STATE OF INDIANA
INDIANA UTILITY REGULATORY COMMISSION

CAUSE NO. 44339

Direct Testimony of
Tyler Comings

On Behalf of
Citizens Action Coalition of Indiana

15 **Figure 1: Base Case PVRR Results for Resource Plans 1 and 3 with Capacity Price**
 16 **Corrections³**

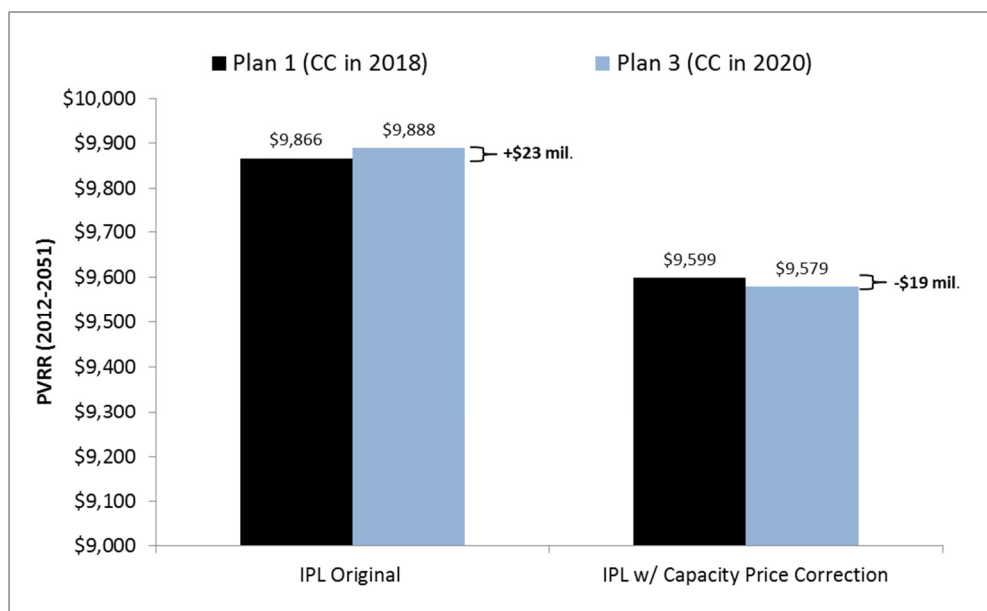
2 **A** Simply substituting the more up-to-date capacity price projection from the
 3 Company changes the outcome and the preferred alternative. Figure 1 shows the
 4 Company's original base case PVRR estimates for building a new natural gas CC
 5 in 2018 and 2020—Resource Plans 1 (in black) and 3 (in light blue), respectively.
 6 The use of older, higher capacity price forecasts leads to a higher PVRR (\$23
 7 million difference) for building the CC for operation in 2020 compared to 2018.²

8 Substituting more up-to-date capacity prices results in a reduction in PVRR--
 9 relative to the Company's original results--of \$267 million for Plan 1 and \$309
 10 million for Plan 3 in the base case. The results show that delaying the build of the
 11 new CC until 2020 is now more favorable than the Company's chosen strategy of
 12 building it for operation in 2018 (\$19 million lower than building in 2018).
 13 Further detail on this analysis is provided subsequently in my testimony.

16 **Figure 2: IPL Peak Load Forecasts (after DSM) used in CPCN1 and BCPCN**
 17 **modeling¹⁰**

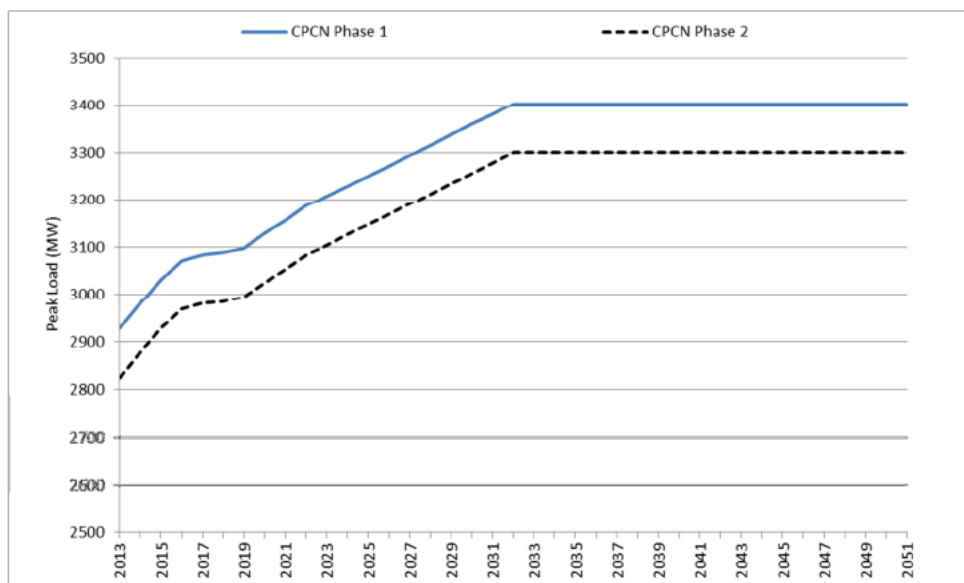
10 **A** No, the Company included additional demand response in their modeling of the
 11 CC build options (“CPCN Phase 2”) but not in their resource plan modeling
 12 (“CPCN Phase 1”). Figure 2 shows this discrepancy which accounts for 103 MW
 13 of peak load that was unnecessarily included in their estimate of capacity need
 14 when estimating the PVRR of their six resource plans.⁹

Figure 5: Base Case PVRR Results for Resource Plans 1 and 3 with Capacity Price Corrections¹⁷

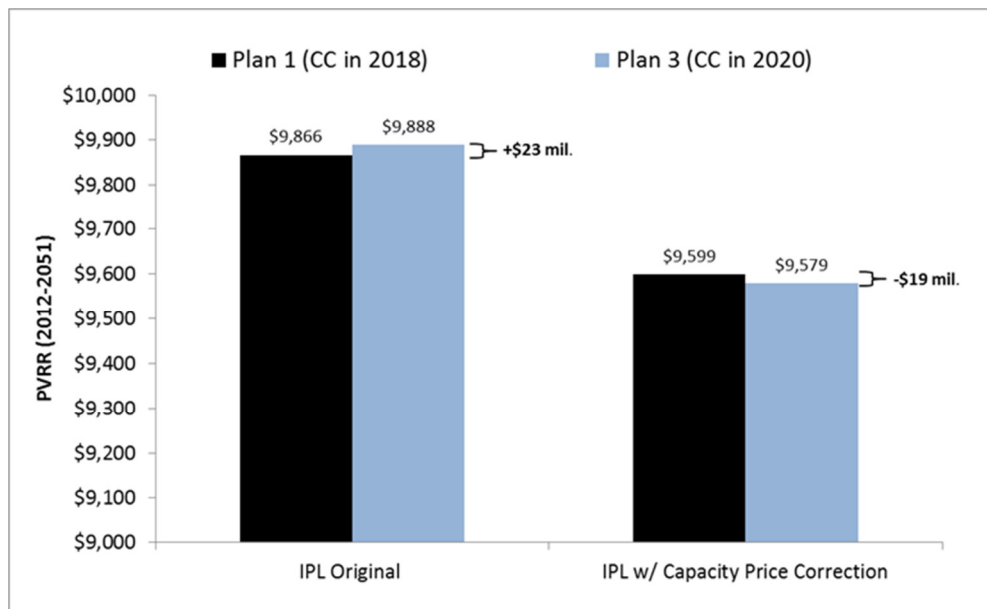
7 Yes. I performed an alternative estimate of present value revenue requirements for
8 both of the Company's resource plans involving a new gas CC plant—shown in
9 Figure 5, below. The Company concluded that building a CC in 2020 (in light blue)
10 had a \$23 million higher PVRR than building it in 2018 (in black). However,
11 using the Company's more up-to-date capacity price forecasts, the updated results
12 show that delaying the build until 2020 is more favorable than building it in 2018,
13 now with a \$19 million lower PVRR.
